Comments on Draft report- E on- Kentucky Utilities- Pineville Generating Station

**Re: Kentucky Utilities' Comments on
*DRAFT Report of Geotechnical Investigation Dam Safety Assessment of Coal Combustion Surface
Impoundments Kentucky Utilities, a Subsidiary of E.ON U.S. Pineville Generating Station, Pineville, Kentucky***

**KU Comments-clerical and technical corrections to
*DRAFT Report of Geotechnical Investigation Dam Safety Assessment of Coal Combustion
Surface Impoundments
Kentucky Utilities, a Subsidiary of E.ON U.S.
Pineville Generating Station, Pineville, Kentucky***

Table 1

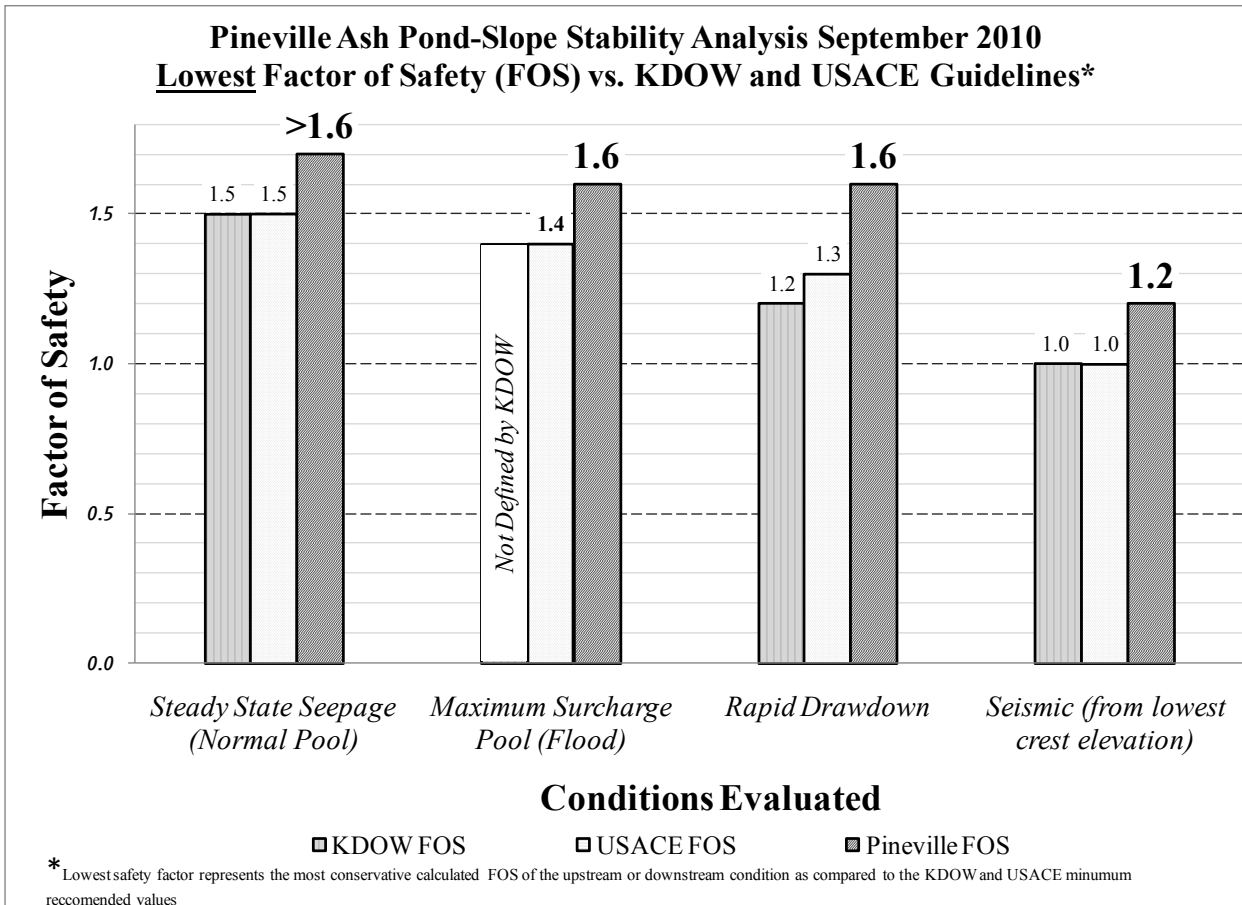
KU Notes: A comprehensive geotechnical exploration and slope stability analysis for the Pineville Ash Pond was completed in September, 2010 and is included as attachment 2. The results of the analysis are summarized in Table 1.
